ANSI/ASHRAE/IESNA Addenda d, o, x, aa, ab, ae, at, au, and ba to
ANSI/ASHRAE/IESNA Standard 90.1-2007

Energy Standard for Buildings Except Low-Rise Residential Buildings

Addendum d to 90.1-2007

Figure 9.1 Elevation of *daylit area* under *skylights*.

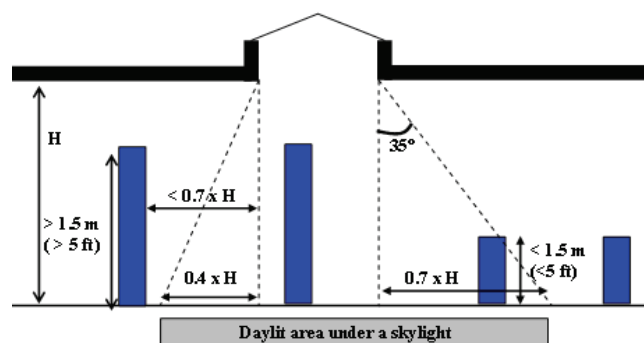
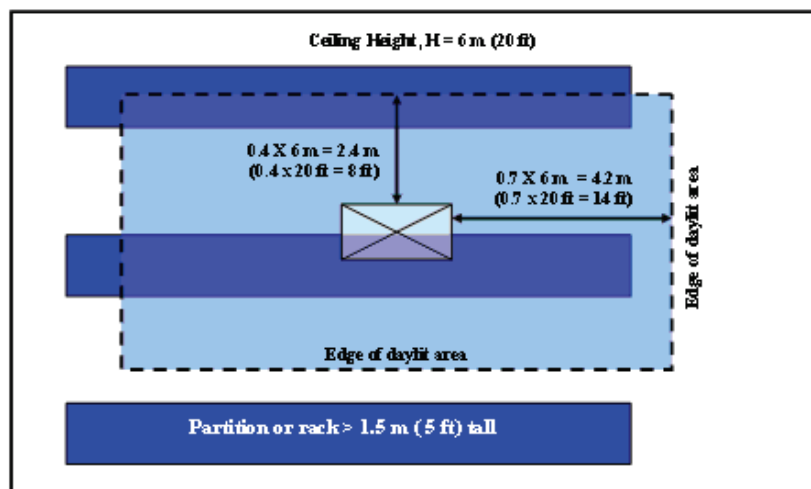
9.4.1.3 Daylit area under skylights. The *daylit area* under each *skylight* shall be

- the outline of the opening beneath the skylight, plus 70% of the ceiling height in each horizontal direction when there are no *permanently installed* partitions and racks with heights greater than 5 feet (1.5 m) within a horizontal distance of 70% of the ceiling height to the edge of the skylight (See Figures 9.1 and 9.2) or
- the outline of the opening beneath the *skylight*, plus 40% of the ceiling height in the horizontal directions perpendicular to the racks or partitions, plus 70% of the ceiling height (See Figure 9-1) in directions parallel to the racks or partitions and
- identified on the building plans.

9.4.1.4 Automatic Daylighting Controls. When the combined *daylit area under skylights* for all *skylights* in an enclosed space exceeds 5000 ft² (500 m²), the lamps for

Figure 3.2 Computing the daylight area under rooftop monitors.

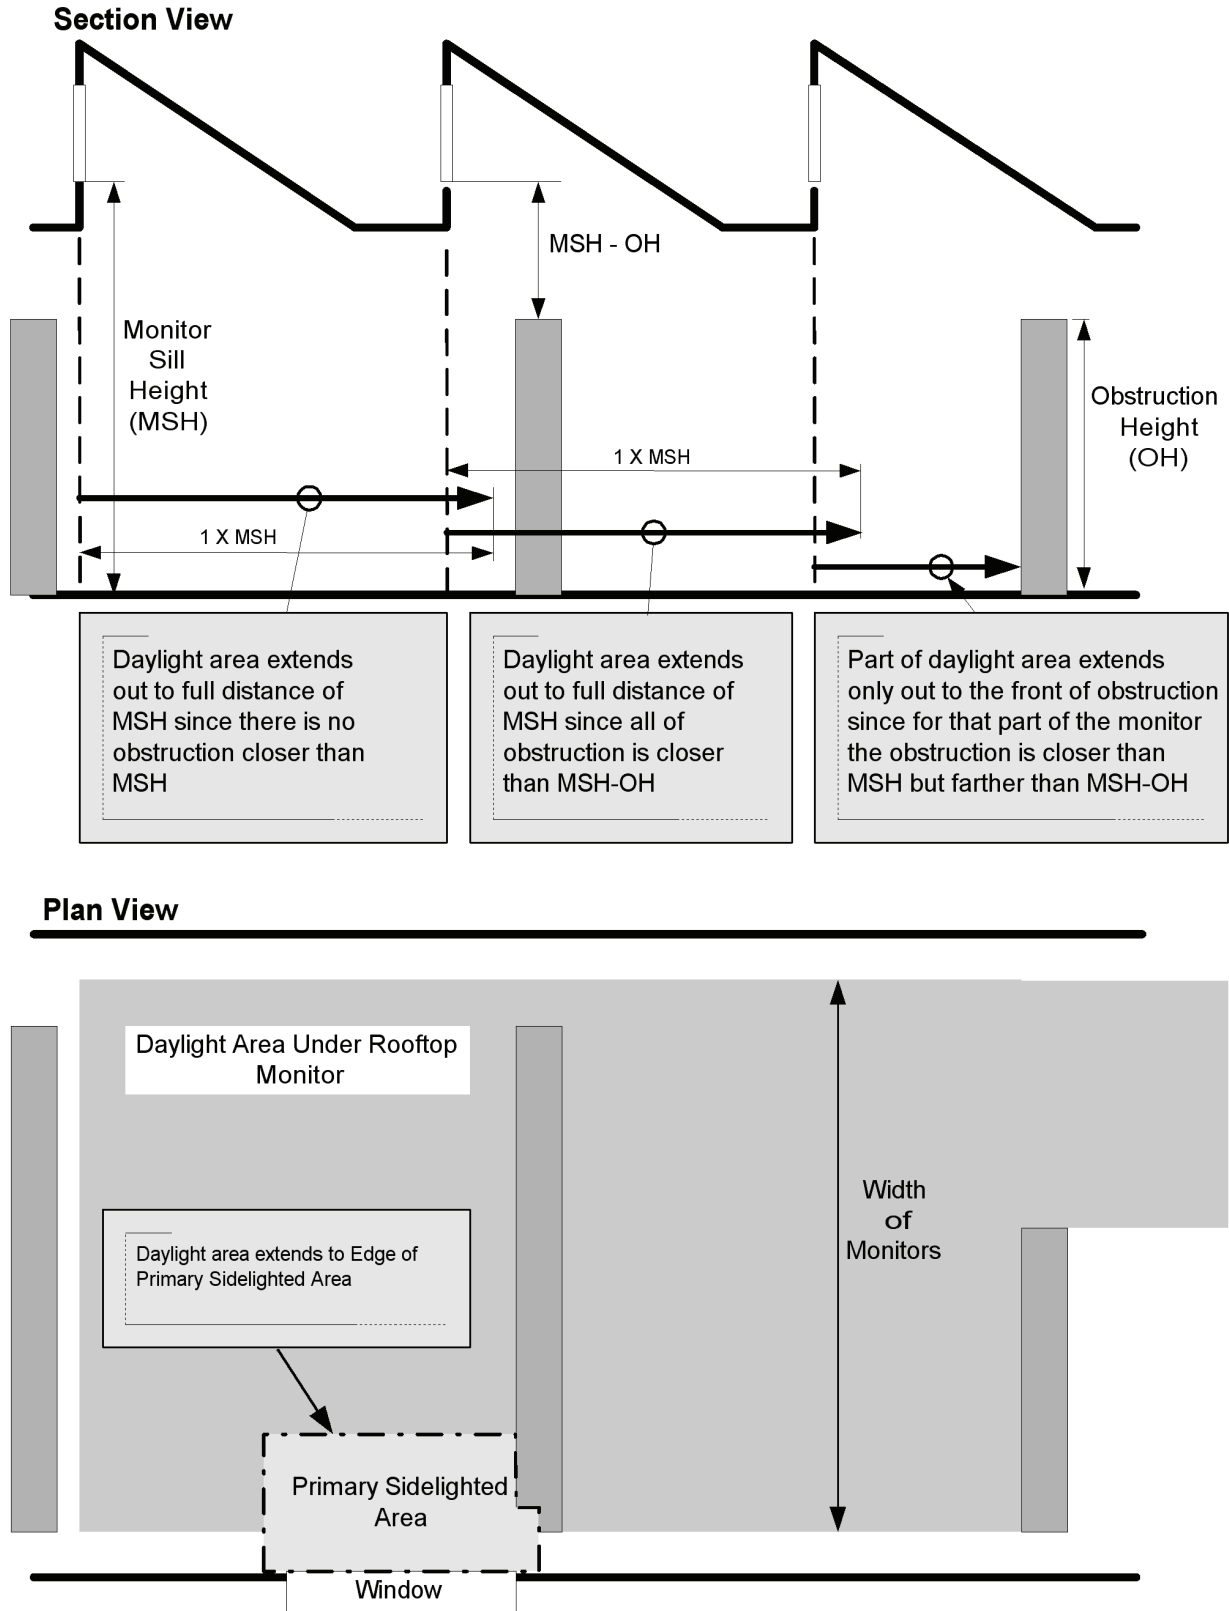
b. **under rooftop monitors:** the daylight area under rooftop monitors is the combined daylight area under each rooftop monitor without double counting overlapping areas. The daylight area under each rooftop monitor is the product of the width of the vertical glazing above the ceiling level and the smallest of the following horizontal distances inward from the bottom edge of the glazing. (See Figure 3.2):

1. the monitor sill height, MSH, (the vertical distance from the floor to the bottom edge of the monitor glazing), or
2. the distance to the edge of any primary sidelighted area or
3. the distance to the front face of any vertical obstruction where any part of the obstruction is

farther away than the difference between the height of the obstruction and the monitor sill height (MSH-OH).

Figure 3.4 Computing the *primary sidelighted area*.

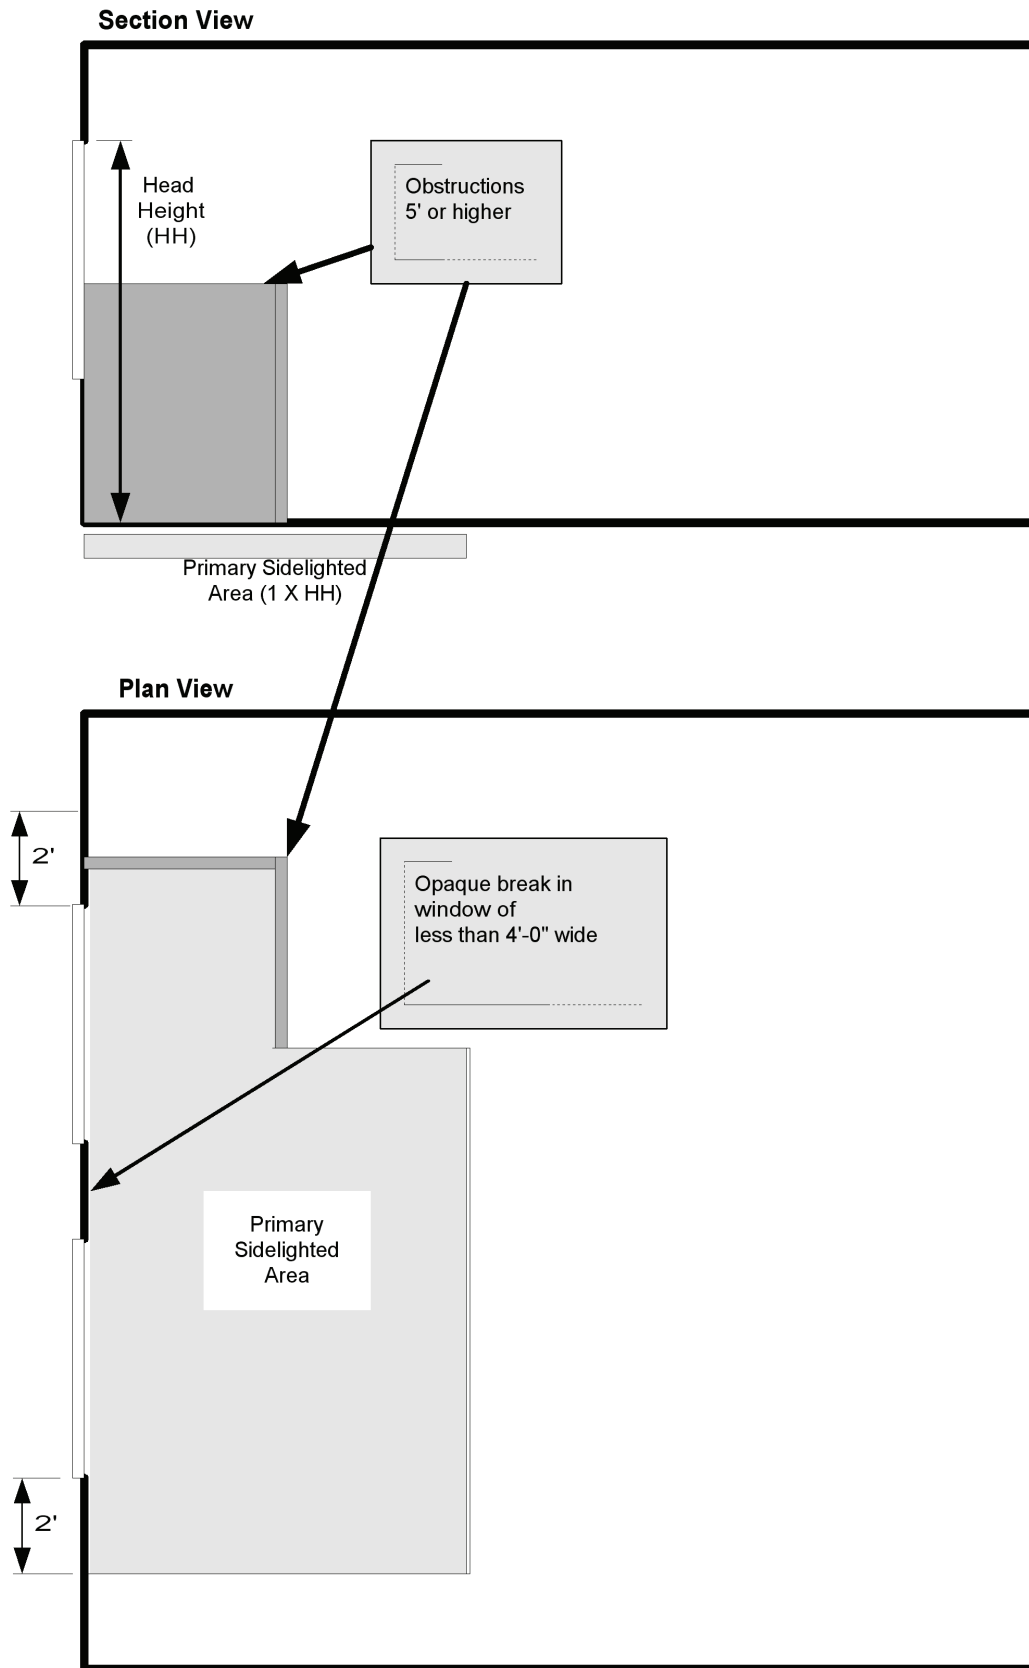
Primary sidelighted area: the total primary sidelighted area is the combined primary sidelighted area without double counting overlapping areas. The floor area for each primary sidelighted area is directly adjacent to vertical glazing below the ceiling with an area equal to the product of the primary sidelighted area width and the primary sidelighted area depth. See Figure 3.3.

The primary sidelighted area width is the width of the window plus, on each side, the smallest of:

1. 2 feet (0.6 m) or
2. the distance to any 5 ft(1.5 m) or higher vertical obstruction.

The Primary sidelighted area depth is the horizontal distance perpendicular to the glazing which is the smaller of:

1. one window head height (head height is the distance from the floor to the top of the glazing), or
2. the distance to any 5 ft (1.5 m) or higher vertical obstruction.

Figure 9.1 Elevation of *daylit area under skylights*.

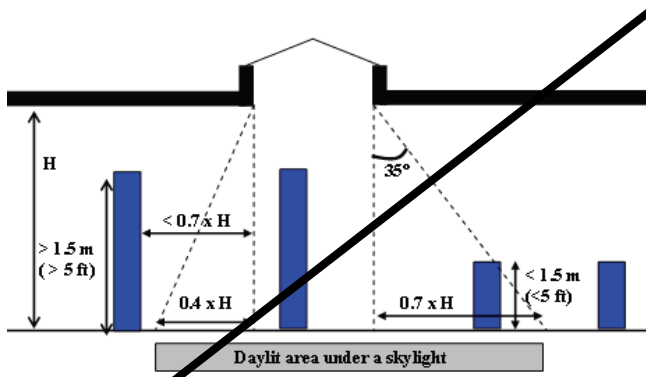
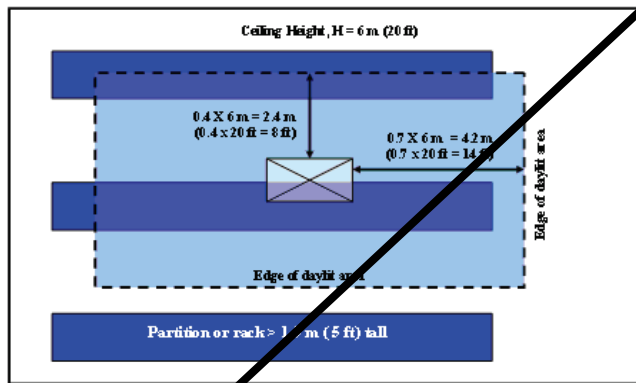
~~9.4.1.3 Daylit area under skylights. The daylit area under each skylight shall be:~~

- ~~The outline of the opening beneath the skylight, plus 70% of the ceiling height in each horizontal direction when there are no permanently installed partitions and racks with heights greater than 1.5 m within a horizontal distance of 70% of the ceiling height to the edge of the skylight (See Figures 9-1 and 9-2) or~~
- ~~The outline of the opening beneath the skylight, plus 40% of the ceiling height in the horizontal directions perpendicular to the racks or partitions, plus 70% of the ceiling height (See Figure 9-1) in directions parallel to the racks or partitions.~~
- ~~Identified on the building plans.~~
